PROPOSED CHANGE RTS-211 TO THE
DUANE ARNOLD ENERGY CENTER
TECHNICAL SPECIFICATIONS

The holders of license DPR-49 for the Duane Arnold Energy Center propose to amend Appendix A (Technical Specifications) to said license by deleting current pages and replacing them with the attached, new pages. The List of Affected Pages is given below.

POWER-DEPENDENT MINIMUM CRITICAL
 POWER RATIO MULTIPLIER (K_p)
 FIGURE 3.12-2

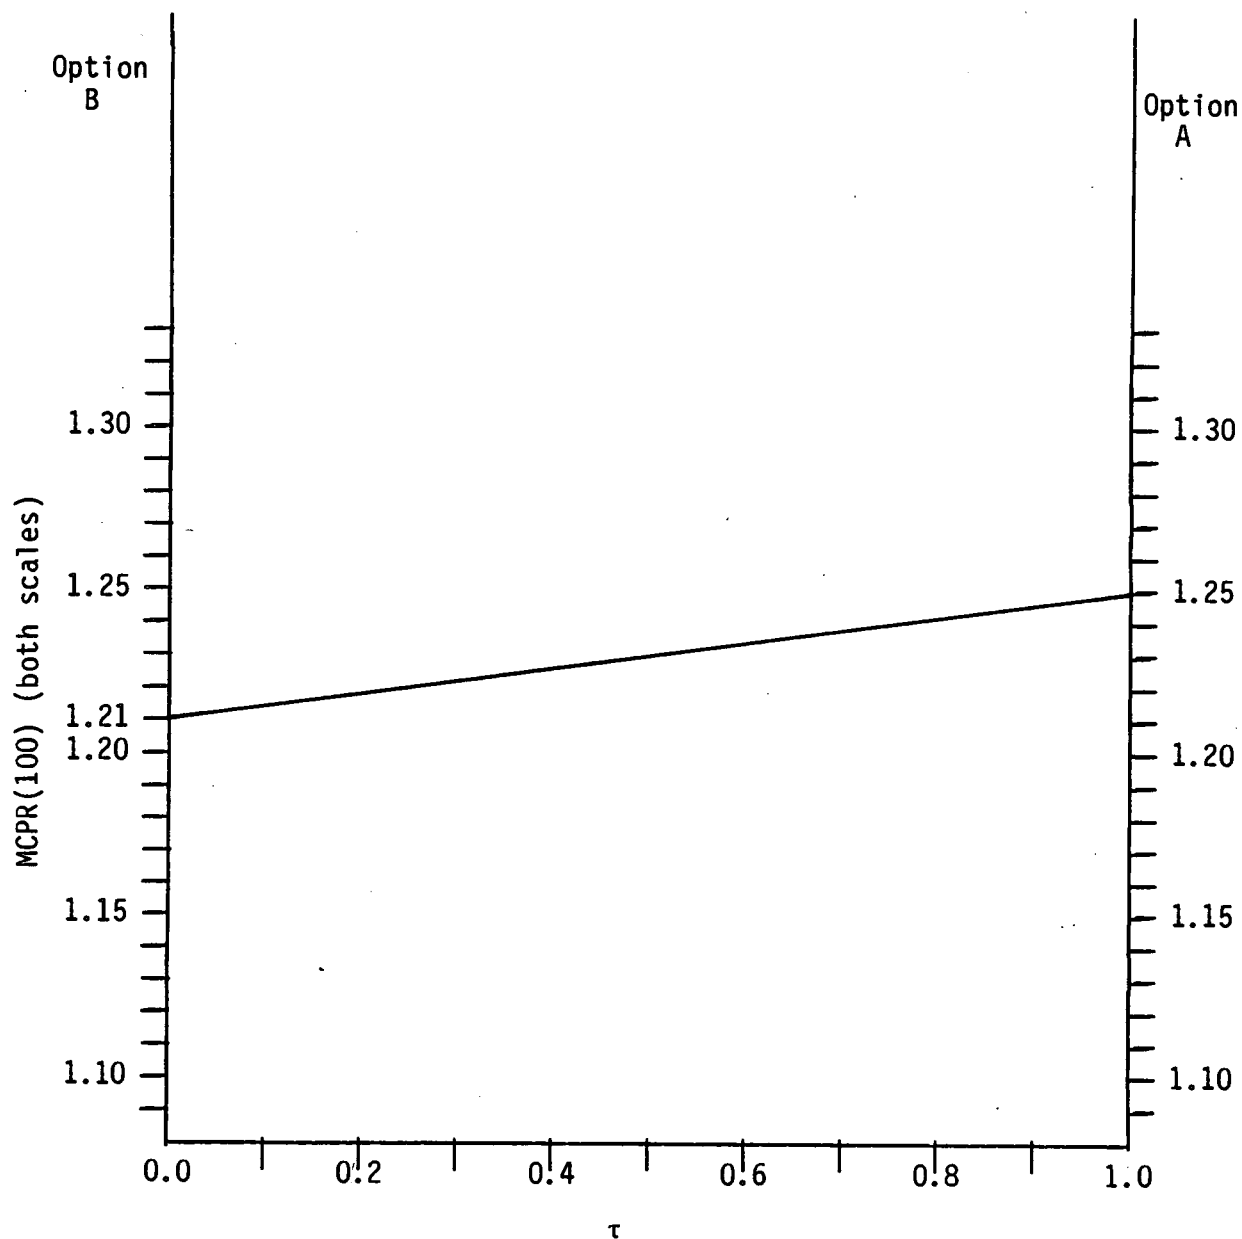
- f) Renumber existing Figure 3.12-4 (K_p) as Figure 3.12-2.
 - g) Capitalize all terms used in Sections 3.12 and 4.12 which are defined in Section 1.0.

FIGURE 3.12-3

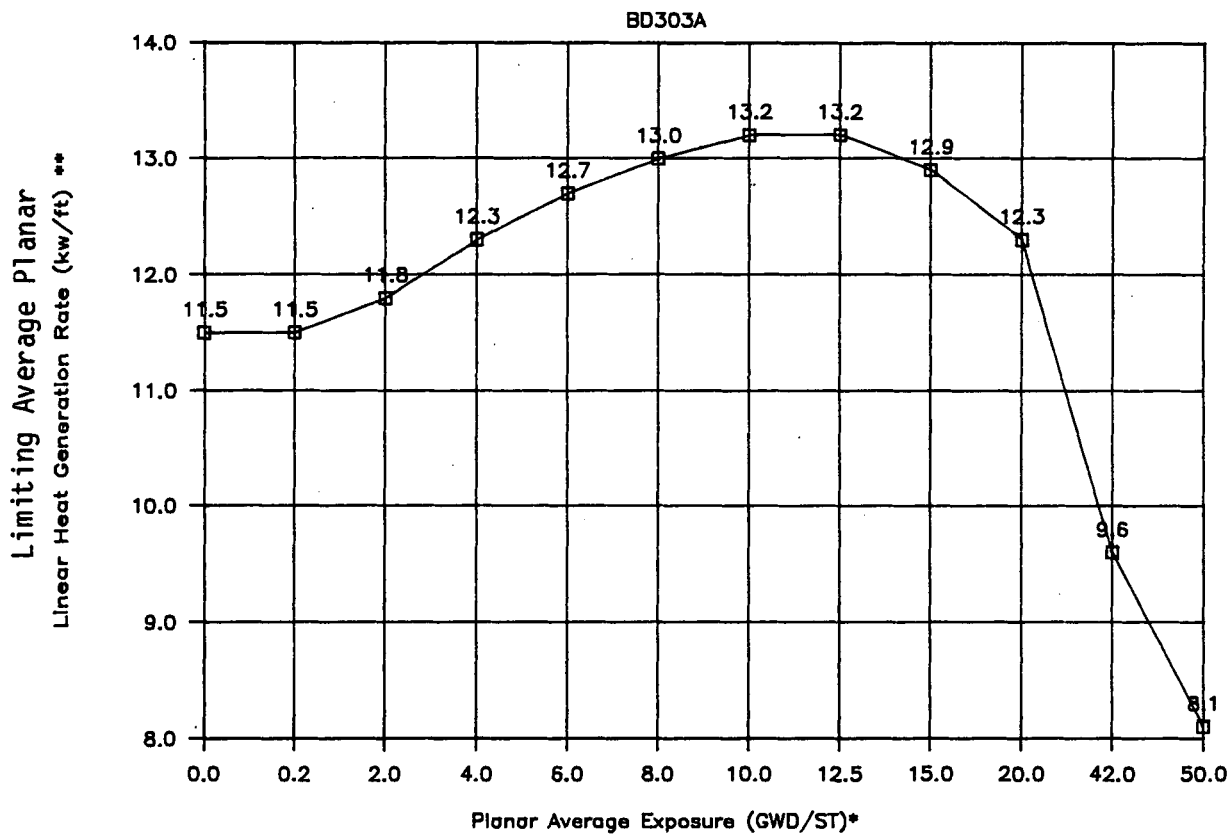
- d) Revise the LCO statements for LHGR to reflect the higher limit for the new GE8B fuel.
 - e) Revise Figure 3.12-3 to reflect the new MCPR(100) limits for all fuel types during Cycle 9 operation and delete Figure 3.12-2.

FIGURE 3.12-4

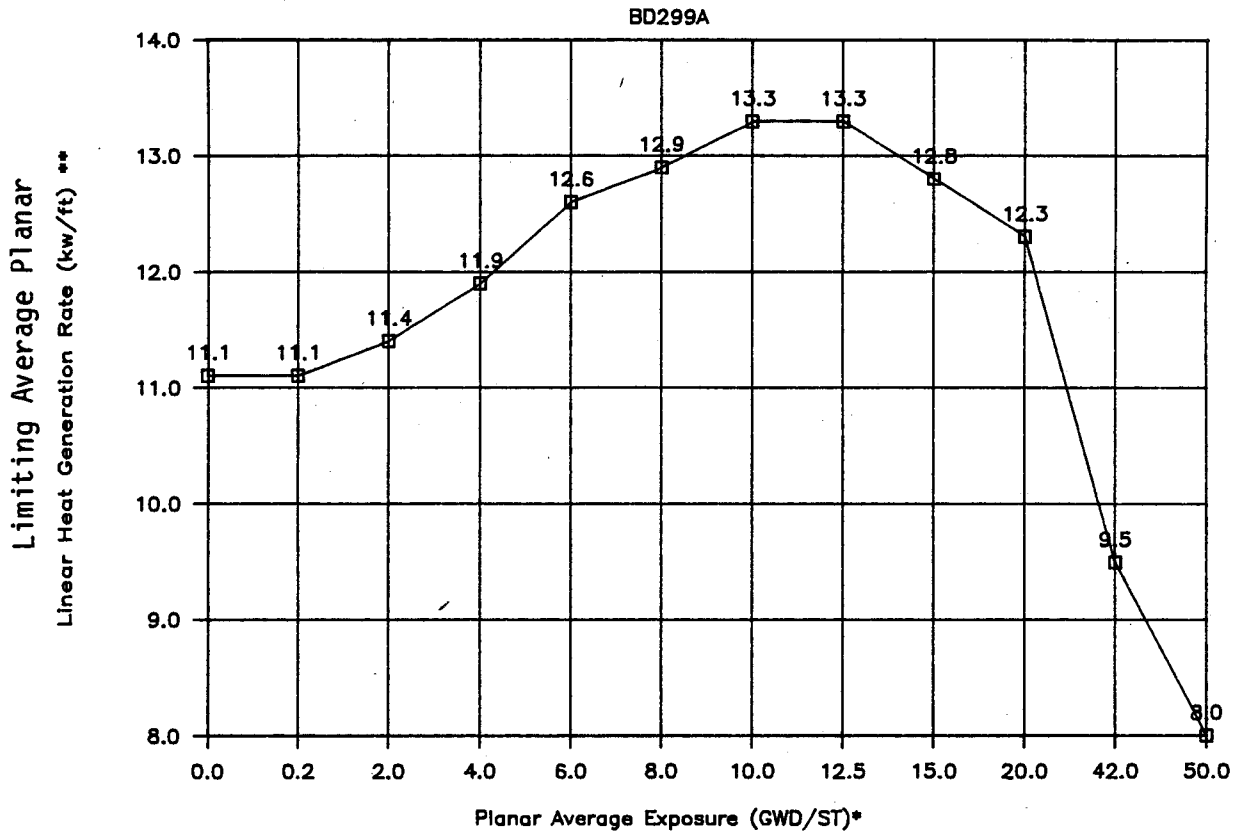
- 1) Revise the List of Figures (pages vii and viii) to delete the MAPLHGR curves for the old fuel (Fig. 3.12-7); add the MAPLHGR curves for the new fuel (new Figures 3.12-4 and 3.12-7); consolidate Figures 3.12-2 and -3 (MCPR vs. τ) into one Figure (Fig. 3.12-3) and renumber existing Figure 3.12-4 as 3.12-2; delete Figure 3.12-12 (MAPFAC_F for LTA-311) and renumber Figure 3.12-13 as 3.12-12.

- 5) Revise Sections 3.12 and 4.12 (Core Thermal Limits) as follows:
- a) Revise the LCO statements to include the MAPLHGR limits for the new fuel types and add the new MAPLHGR vs. Exposure Curves for the new fuel.

FLOW-DEPENDENT MAXIMUM AVERAGE PLANAR
LINEAR HEAT GENERATION RATE (MAPLHGR)
MULTIPLIER (MAFFAC_F)
FIGURE 3.12-10

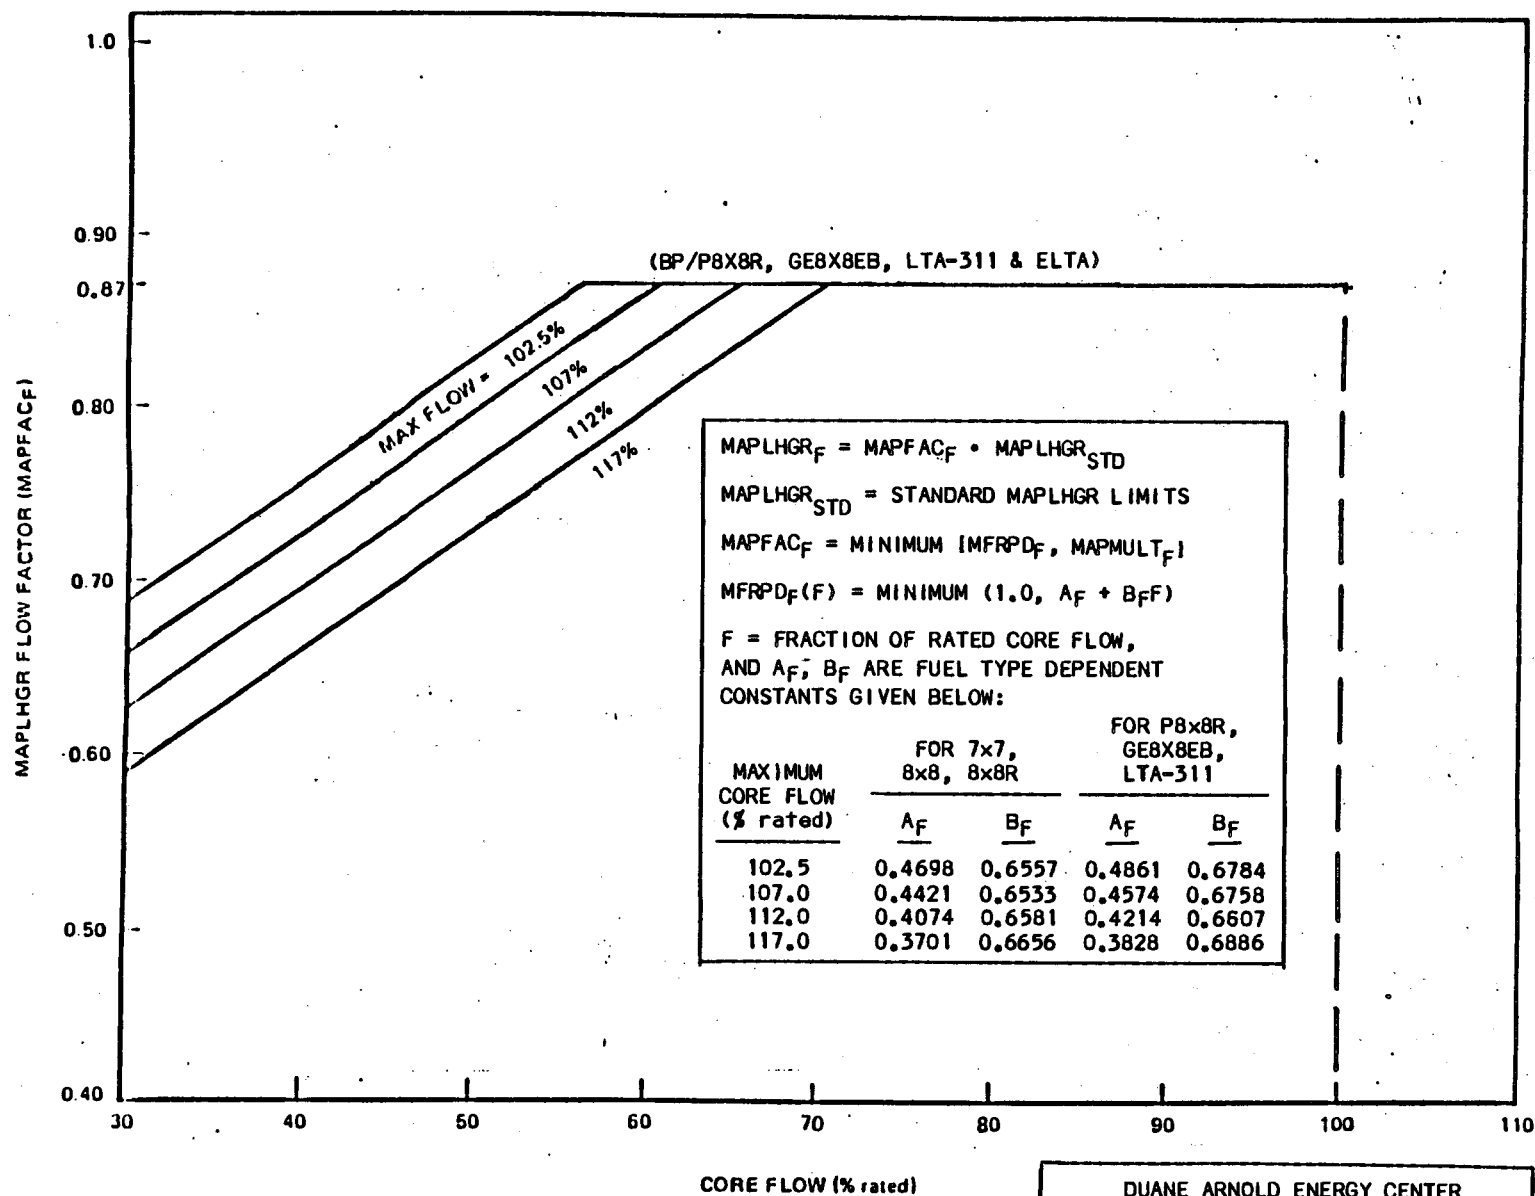
- b) Delete the reference to separate MAPFAC multipliers for the LTA-311 fuel and delete existing Fig. 3.12-12 (MAPFAC_F for LTA-311).
 - c) Revise the MAPFAC_F curves for dual and single loop operation (Figs. 3.12-10 and 3.12-12, respectively) to show they are applicable to all fuel types.
